Planning Board Meeting

June 27, 2023 - 6:30 PM

(Nathan Farber)
 - 4.C. Consider recommendation on Petition #R23-05, Lagoon Bay Beach Club, a request by Bi-Part Development, LLC to rezone +/- 263.01-acres generally located north and south of NC 73, south of Mayes Road, east of Westmoreland Road, north of McCord Road and west of Black Farm Road from existing Rural and Transitional Residential to Traditional Neighborhood Development - Conditional District, Neighborhood Residential - Conditional District, and Highway Commercial - Conditional District for a mixed-use development consisting of approximately 1,183 residential units (250

[Below is the staff analysis from the public hearings based on plans dated 3-3-23. However, a new plan was submitted with revisions dated 6-20-23. That plan is included in the Planning Board agenda packet. The reviewing agencies will complete their review of the 6-20-23 plan within 21 days, no later than July 12, 2023. A revised staff analysis will be prepared once that review is completed. Further, Attachment G is the applicant's response to staff comments on the plan dated 3-3-23, many of which are referred to in this staff analysis)

RZ-3.2

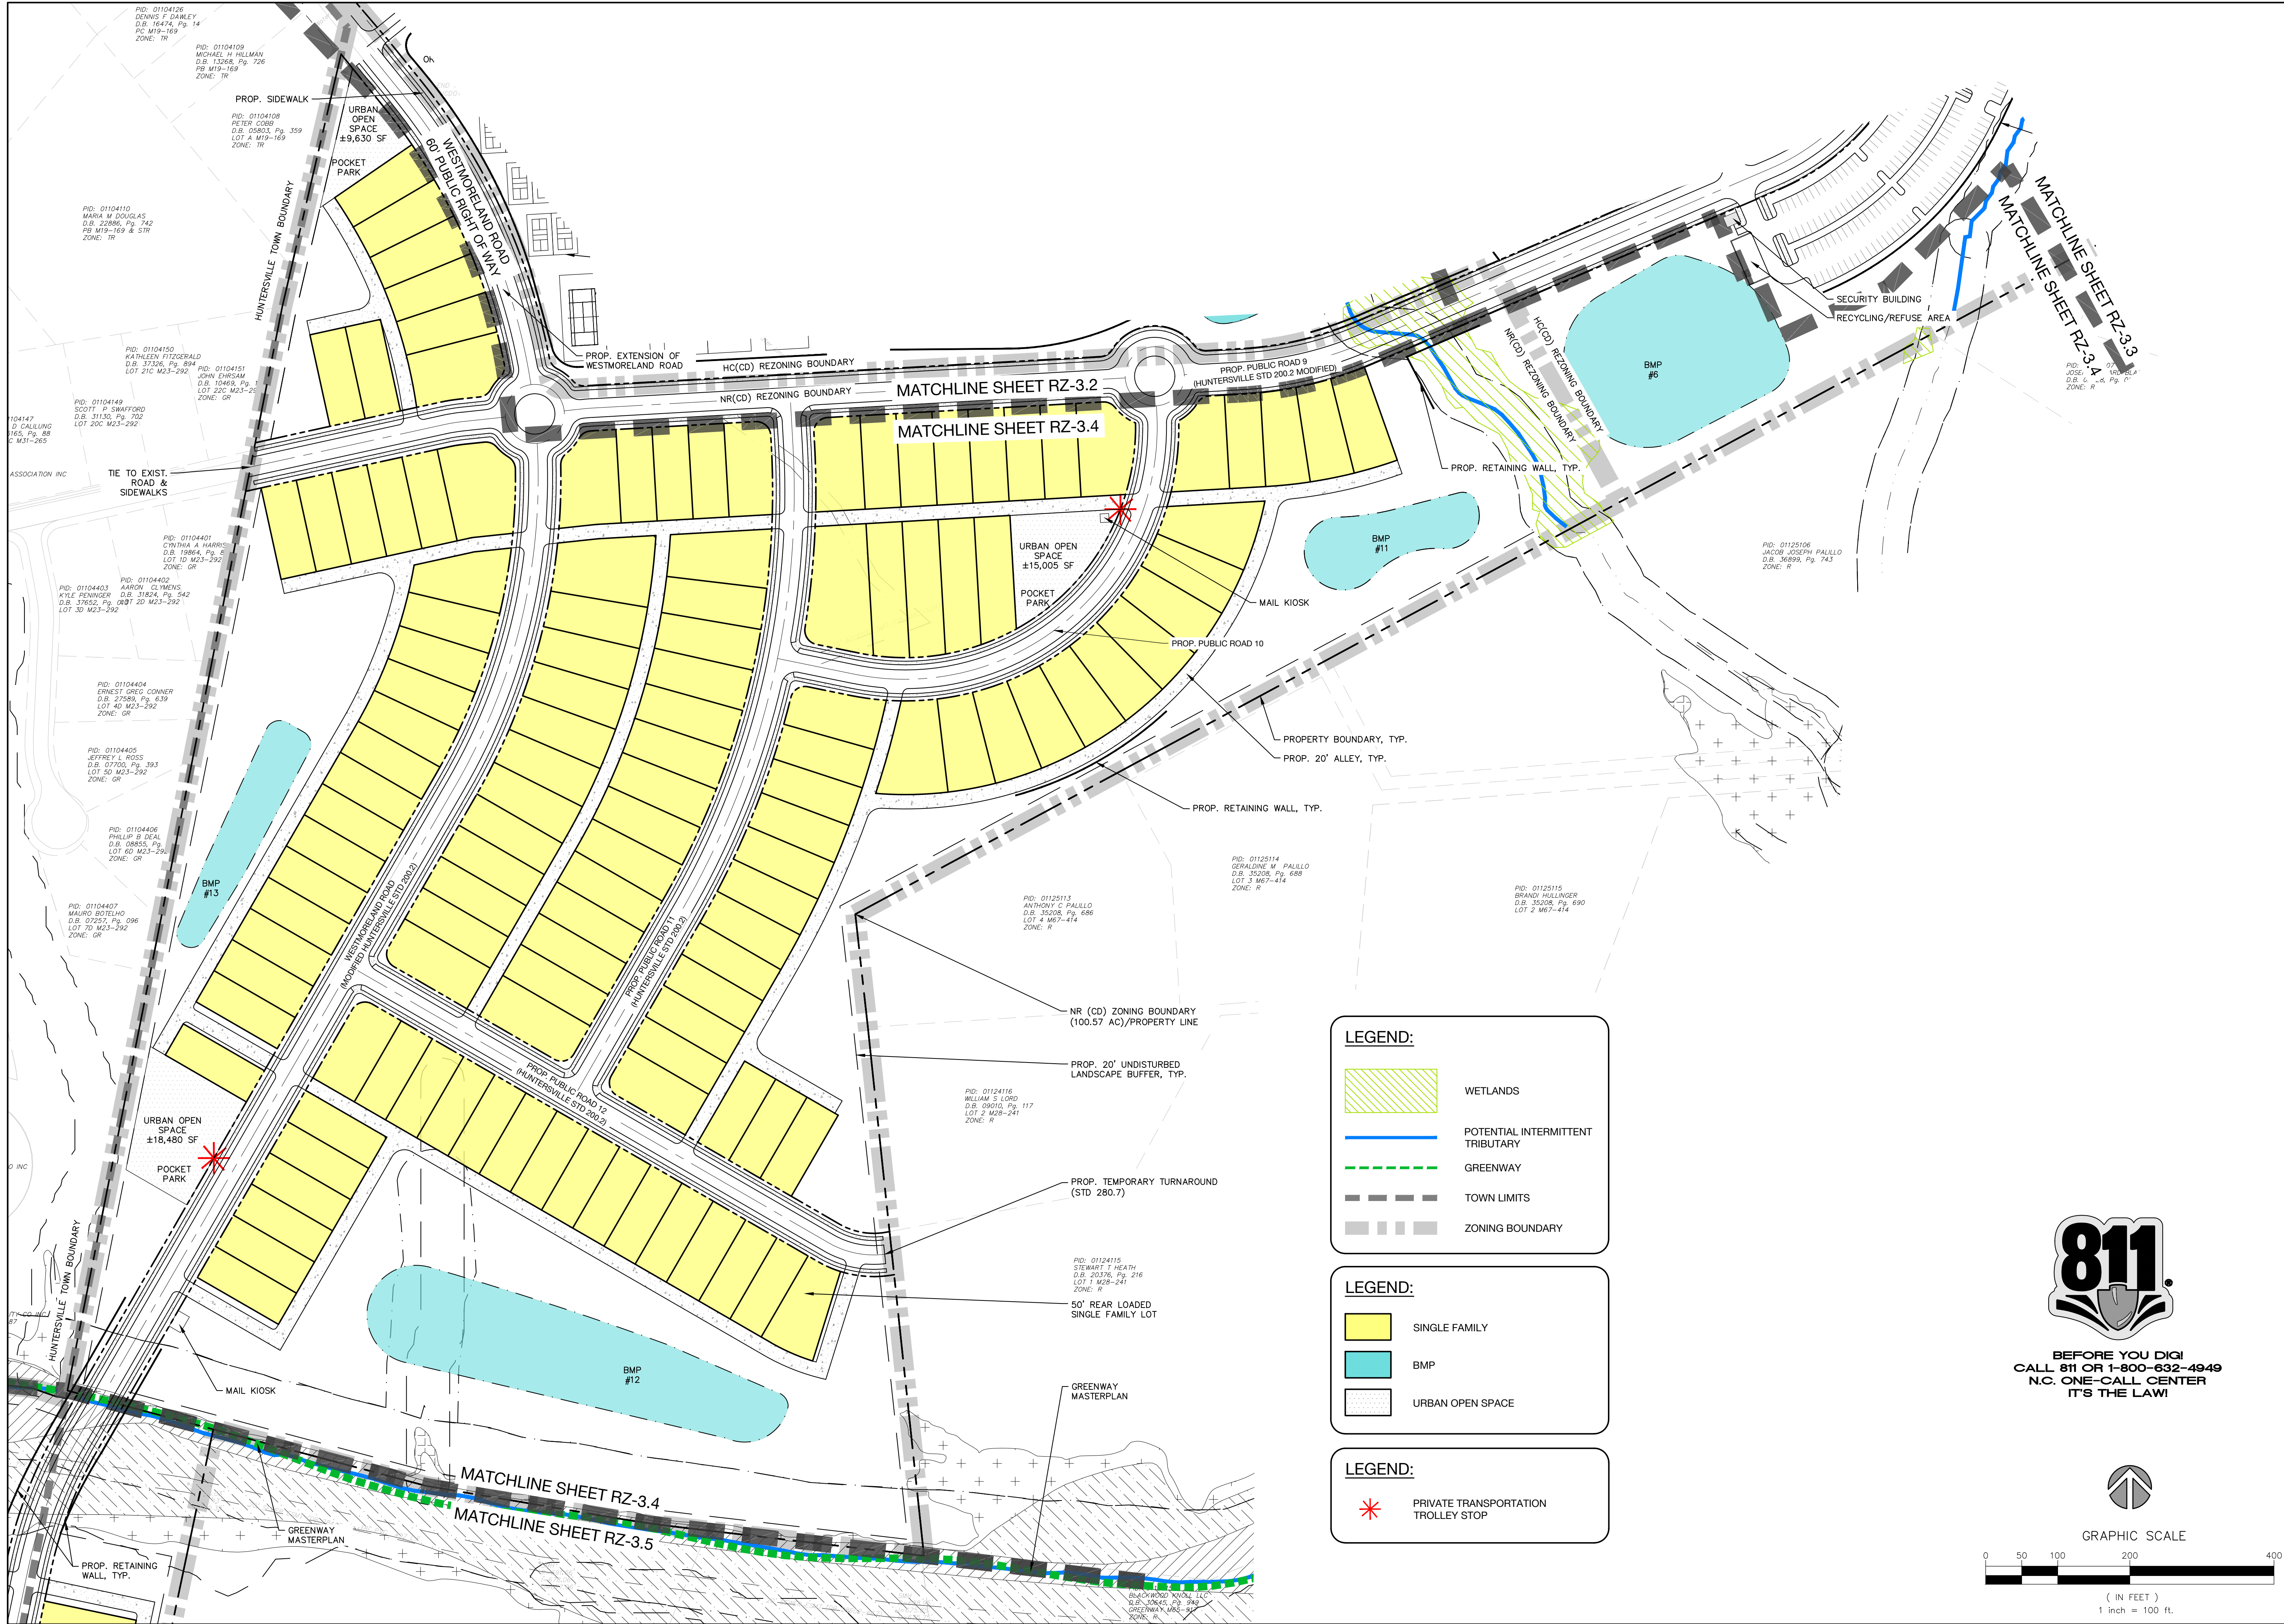
- RECOMMEND 10 ft. sidepath along Westmoreland Road.
 - [HC – Sheet RZ-3.2:](#)
 - All buildings must front a street or Urban Open Space.
 - A berm or other screening should be provided along NC 73 and Westmoreland Road.

- Provide 30% specimen tree save in HC area.
 - Provide pedestrian connection under/across NC 73.
 - Sports fields should be adequately screened.
 - [HC / TND - U RZ-3.3:](#)
